Interactive comment on “On the relationship between wind observation accuracy and the ascending node of sun-synchronous orbit for the Aeolus-type spaceborne Doppler wind lidar” by Chuanliang Zhang et al.

Chuanliang Zhang et al.

Interactive comment on Atmos. Meas. Tech. Discuss., doi:10.5194/amt-2020-202, 2020.

Fig. 1. Comparisons between the wind observations of Rayleigh channel and Mie channel. (a) Wind observation uncertainties; (b) useful signal of atmospheric backscatter; (c) signal excited by SBR.

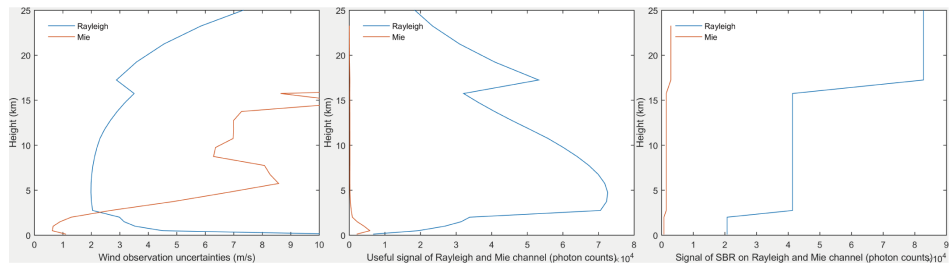
7. In the discussion of Fig. 5 on pages 12-13, the authors should comment on the jump in the required laser pulse energy when going from the troposphere to the stratosphere. It is obviously due to the increase of the bin thickness and the resulting larger Rayleigh channel signals. Furthermore the authors should speculate why less energy is required in PBL, compared to the upper troposphere, though the PBL bin thicknesses are smaller, the laser energy and the Rayleigh channel backscattering damping are larger, and ESA's accuracy requirements are more restrictive in PBL. Is there any cross talk from the Mie channel caused by PBL aerosols?

As to the questions why less energy is required in PBL, in the PBL, the Mie channel wind observation uncertainties is much less than that of Rayleigh channel as Fig. 1(a) at the end of the text shown. However, the photon counts of Mie channel excited by atmosphere aerosols and solar background radiation is also much less than that of Rayleigh channel as Fig. 1(b, c) shown. The optical properties of aerosols are obtained from RMA dataset. So I don't know the reasons for the phenomenon that the wind observation accuracy on Mie channel is higher than that of Rayleigh channel. It may be due to the detection mechanism of Mie channel. Hope for further discussions to the question with reviewers.
